FACPAC Contract Change Order Supplemental Information Form (Ref# 57578)

Tier 1 Project: Phase 6 Additions and Renovations - Project #175-520

CHANGE ORDER NUMBER: 215-01
INITIATION DATE: 3/3/2023

THE CONTRACT IS CHANGED AS FOLLOWS: Contractor Claim #0007 add duct sock per RFI#60 response.

Dwg. Ref:	TH101 AND M104	Spec. Ref:	11 06 00: Stage Rigging Equipment	
FINAL DATE FOR RECEIPT OF INFORMATION WITHOUT IMPACTING CONSTRUCTION SUM OR CONTRACT TIME:				T.B.D.

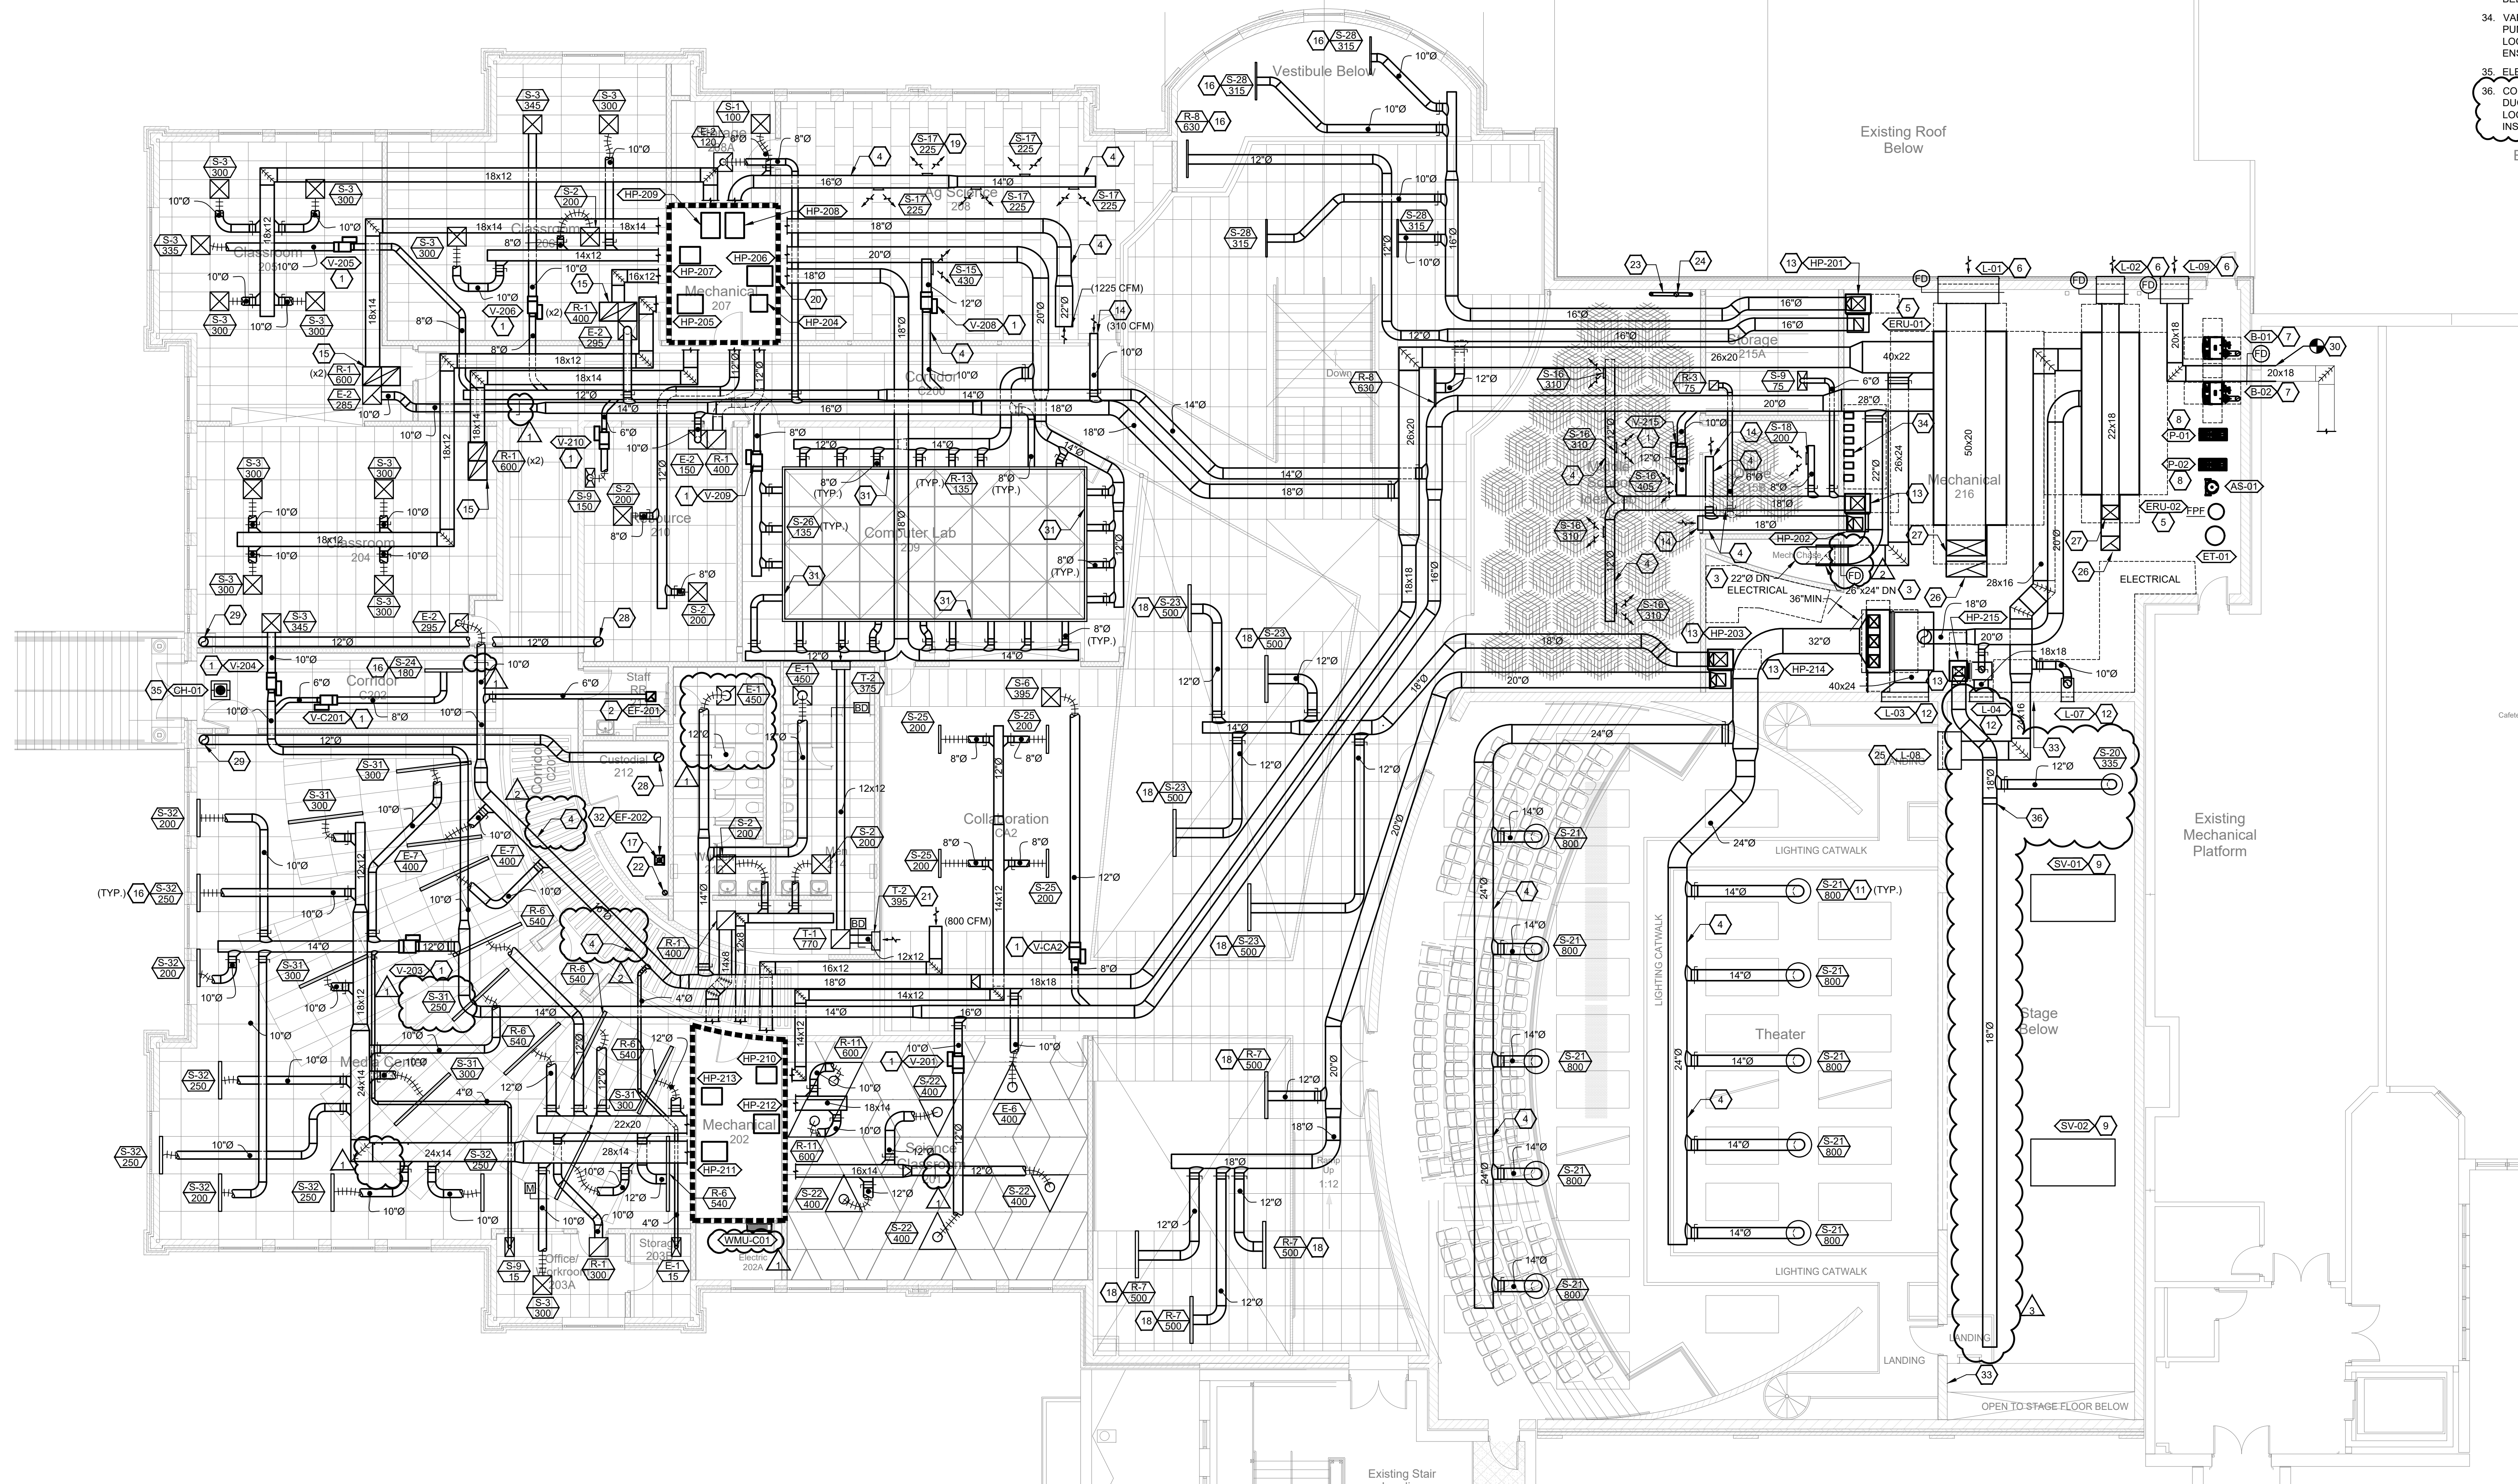
Please review attached marked up contract drawings TH101 and M104.

Ductwork as shown on M104 in the Stage area will interfere with the Stage Rigging. Please refer to attached TH101 for more specific information.

Fire Sprinkler lines and electrical must also be carefully coordinated in the stage area.

18" Ø duct with diffusers across the stage shall be deleted and replaced with 18"Ø DuctSox.
Attached are coordination drawings with Theater Rigging and HVAC.

M104

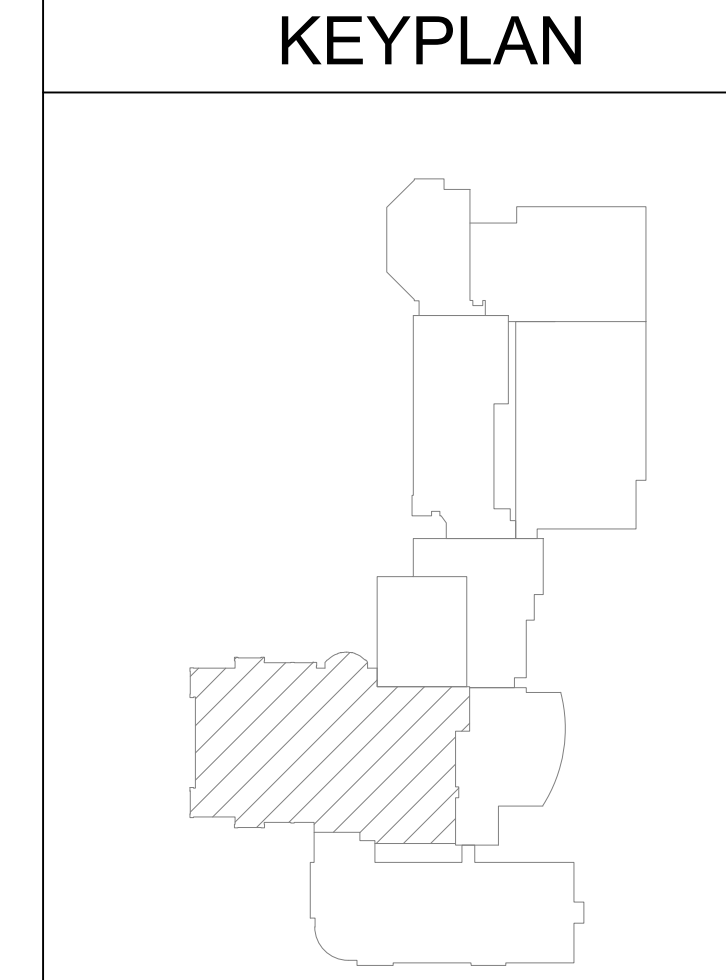
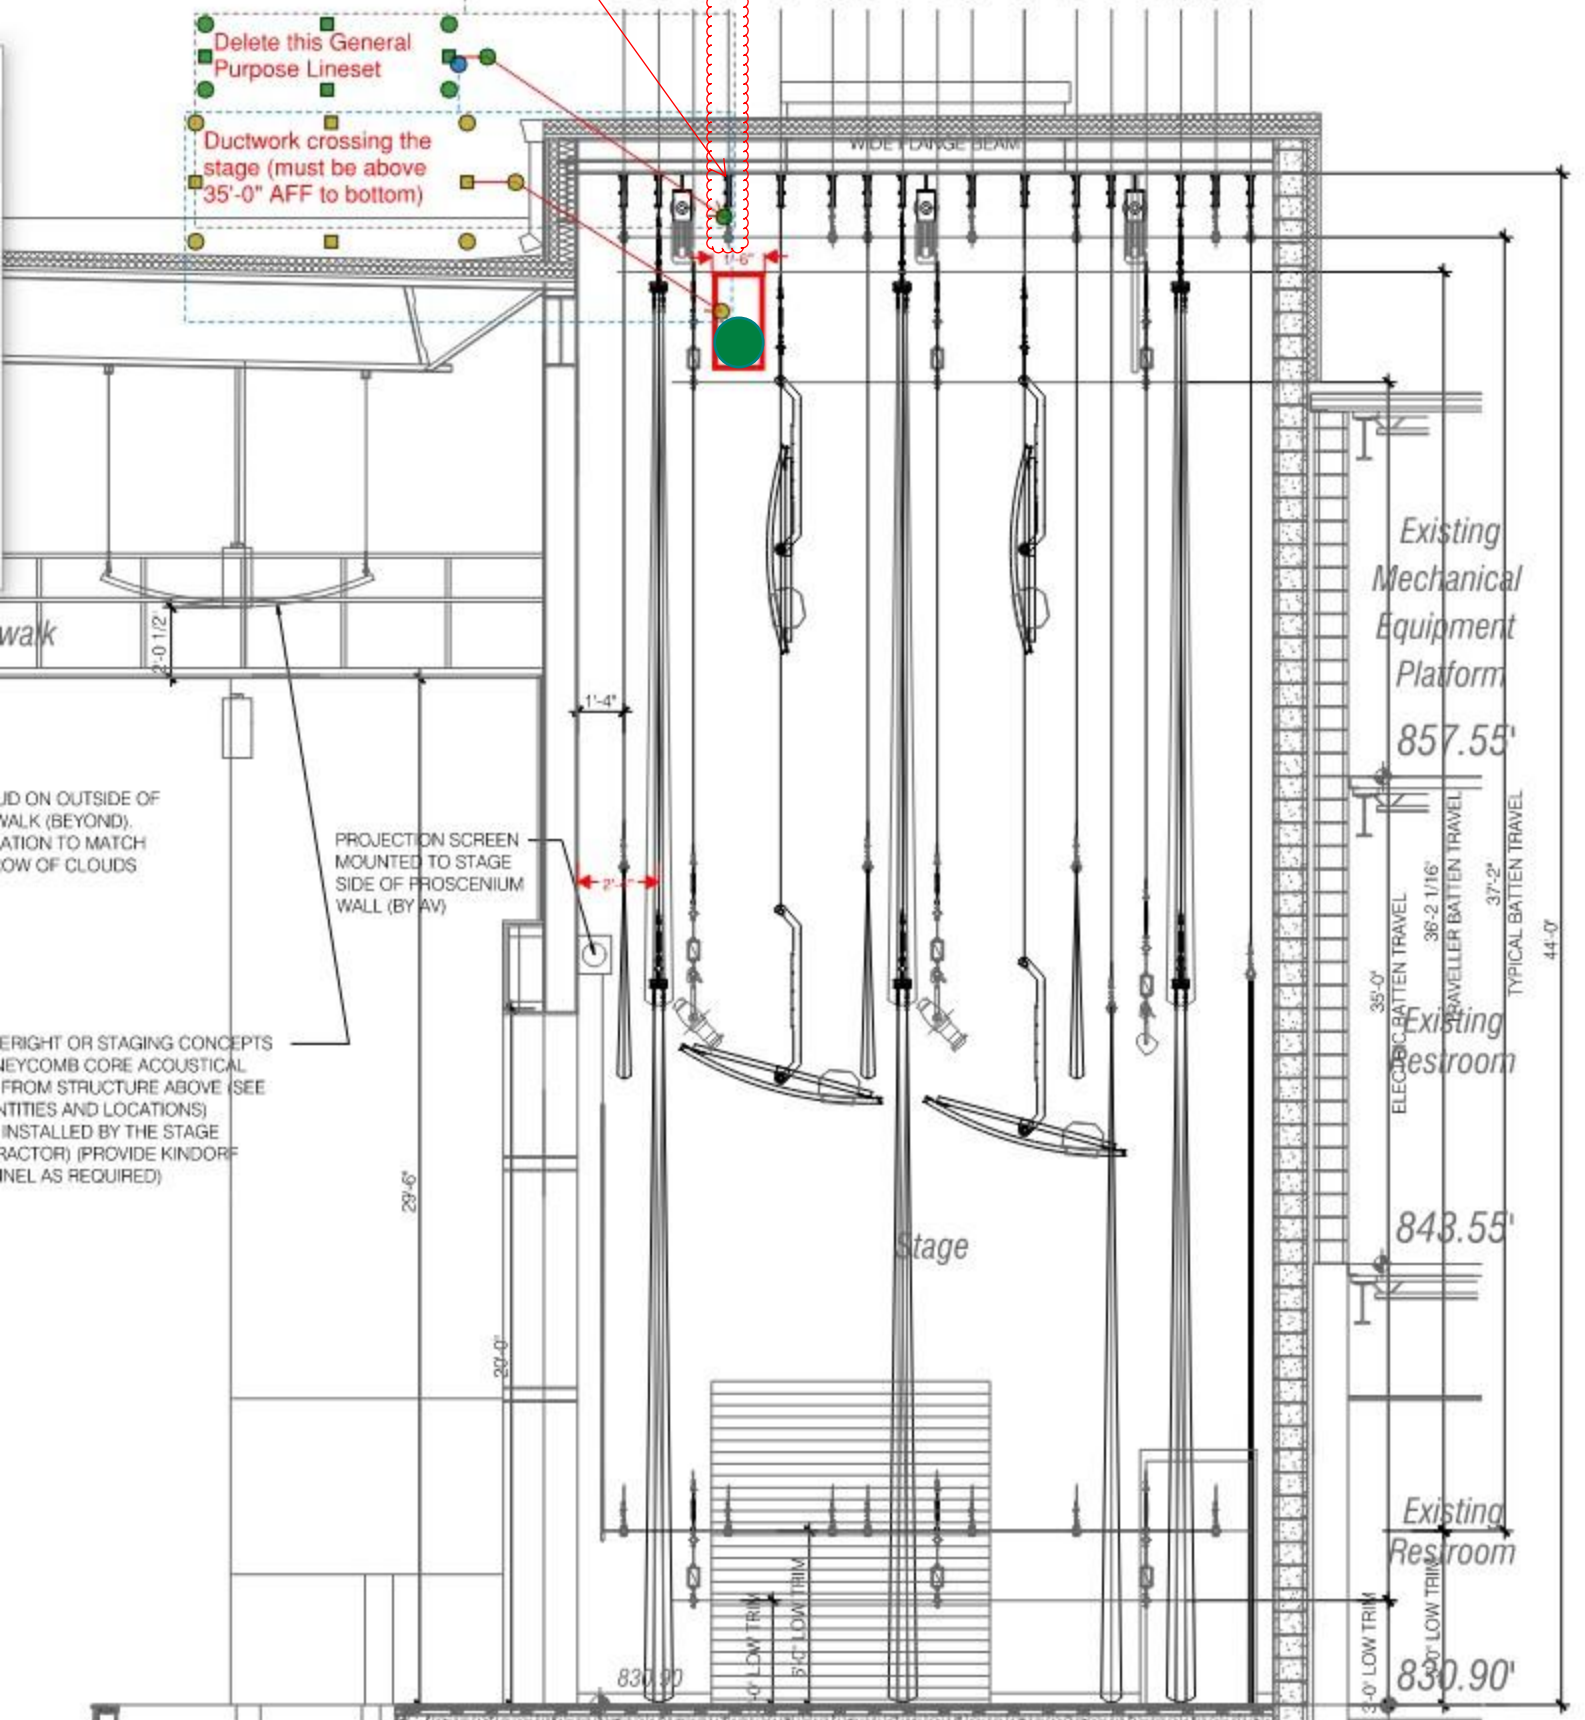
Delete Lineset #4
General Purpose
Lineset

Delete this General
Purpose Lineset

Ductwork crossing the
stage (must be above
35'-0" AFF to bottom)

35. ELECTRIC CEILING HEATER.
36. CONNECT NEW 18"Ø DUCTSOX TO END OF DUCTWORK. DUCTSOX SHALL BE HELD AT 35" AFF. COORDINATE LOCATION WITH THEATER RIGGING PRIOR TO INSTALLATION.
